PRAIRIE ISLAND NUCLEAR GENERATING PLANT UNIT NO. 1

AMENDMENT TO FACILITY OPERATING LICENSE

Amendment No. 11
License No. DPR-42

ATTACHMENT TO LICENSE AMENDMENT NOS. 11 AND 5
FACILITY OPERATING LICENSE NOS. DPR-42 AND DPR-60
DOCKET NOS. 50-282 AND 50-306

FIGURE TS.4.10-1

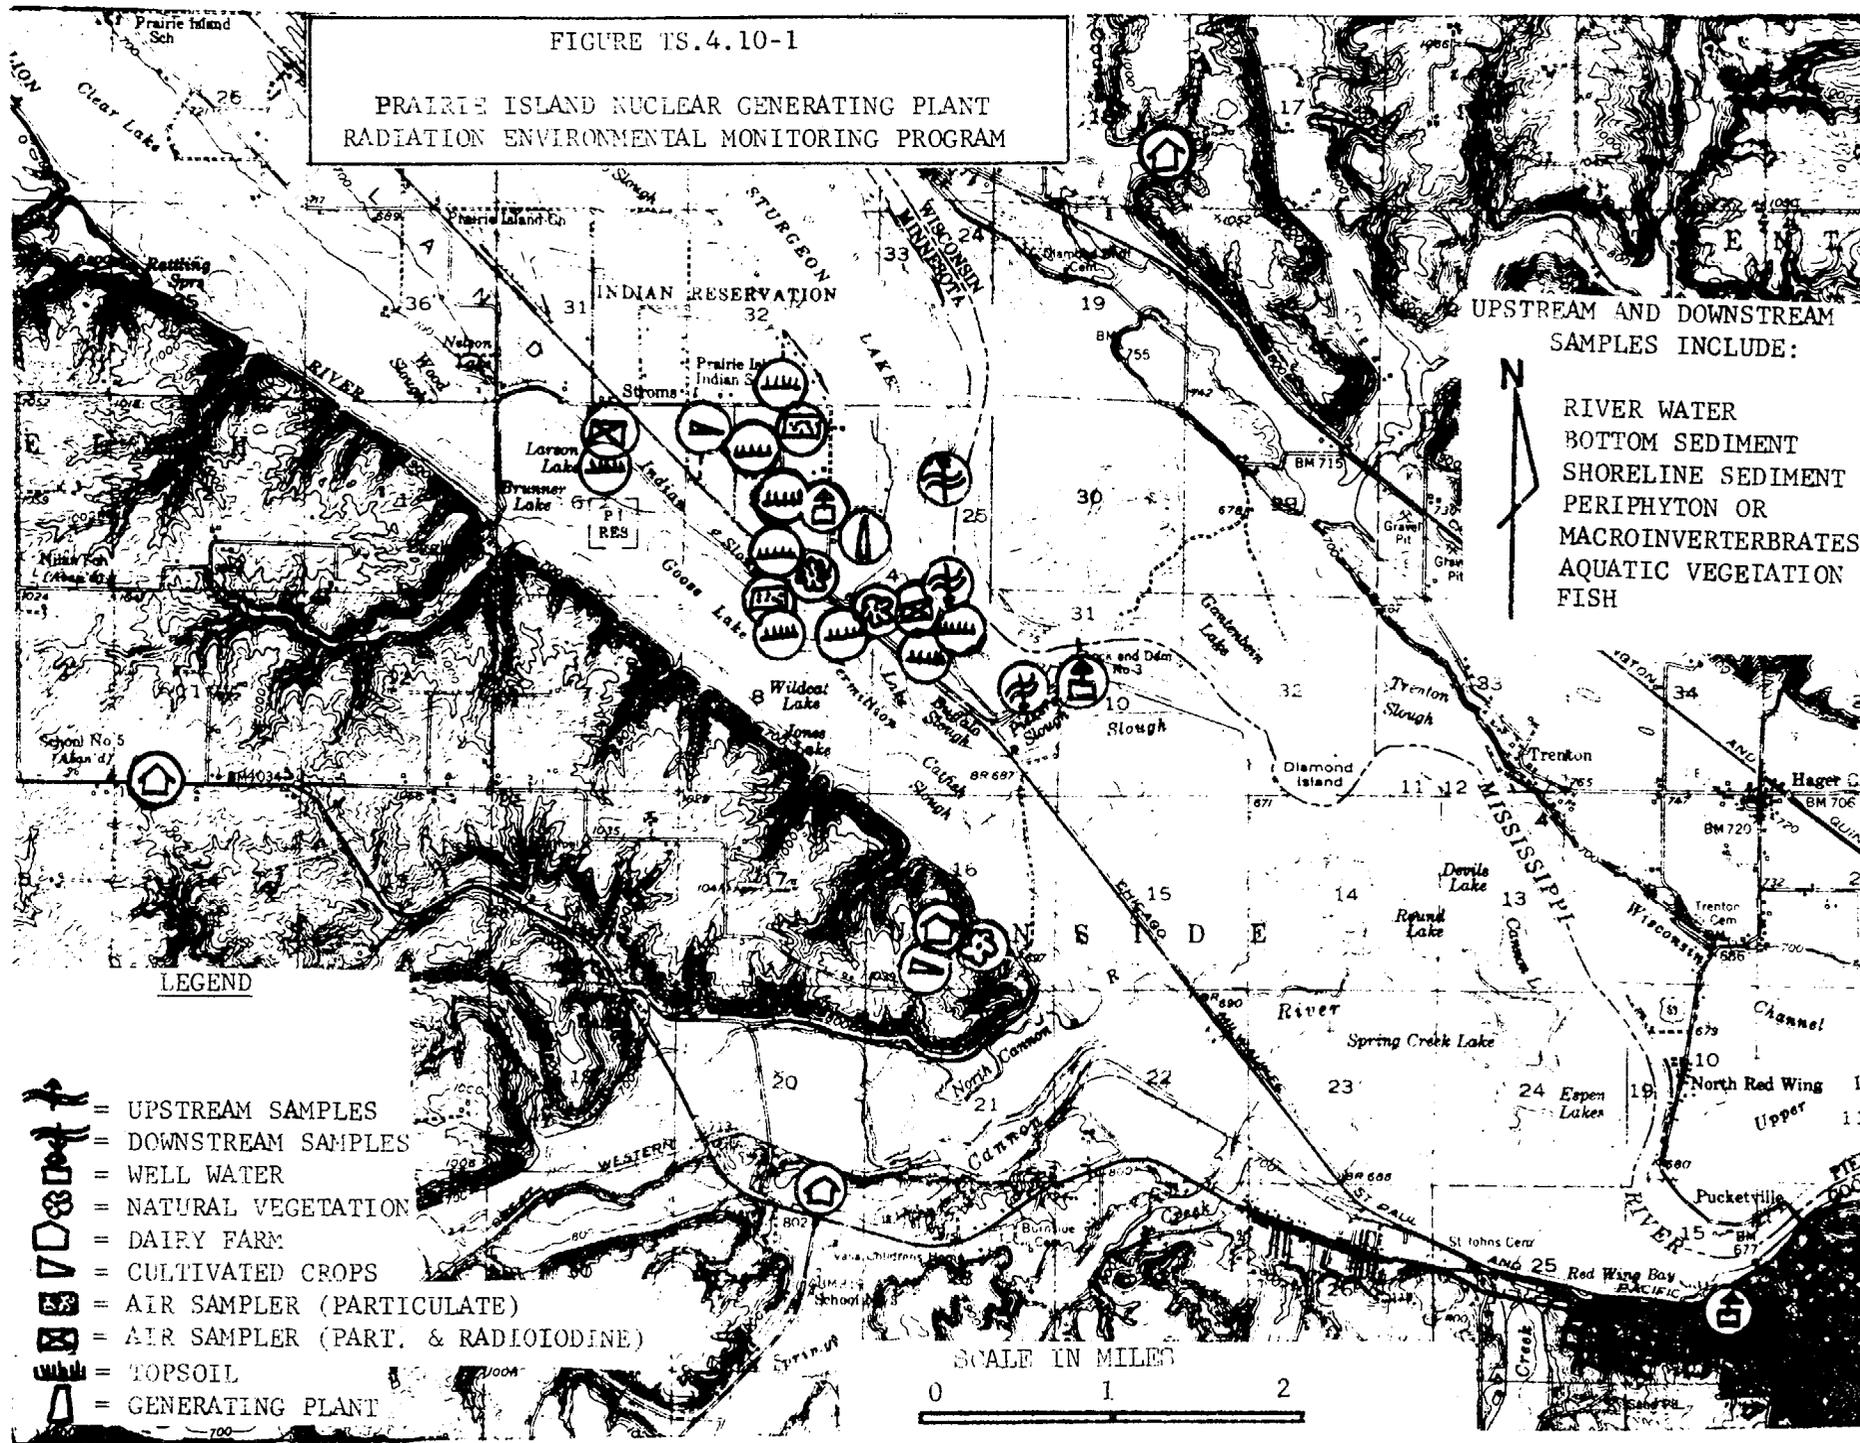
The proposed change dated February 17, 1976, involves changes in environmental samples, sample locations and sampling frequencies which are contained in Section 4.10 "Radiation Environmental Monitoring Program".

The proposed changes in Section 4.10 involve changing samples, sample frequencies and sampling locations. The proposed changes would revise requirements which were found to be impractical and update the monitoring program to include more current regulatory guidance. Based on our review of the program we find that the changes would result in providing equivalent or better information on radioactivity releases than the existing program.

Page TS-i
Page TS-ii
Page TS-iii
Page TS-iv
3.9-1
3.9-2
3.9-3
3.9-5
3.9-6
3.9-8
3.9-9
3.9-10
3.9-11
Table 3.9-1 and 3.9-1 Notes
4.4-3
4.10-1
4.10-2
Table 4.10-1 (four pages)
Figure TS.4.10-1 (new)
Figure TS.4.10-2 (new)
4.12-4
4.12-5
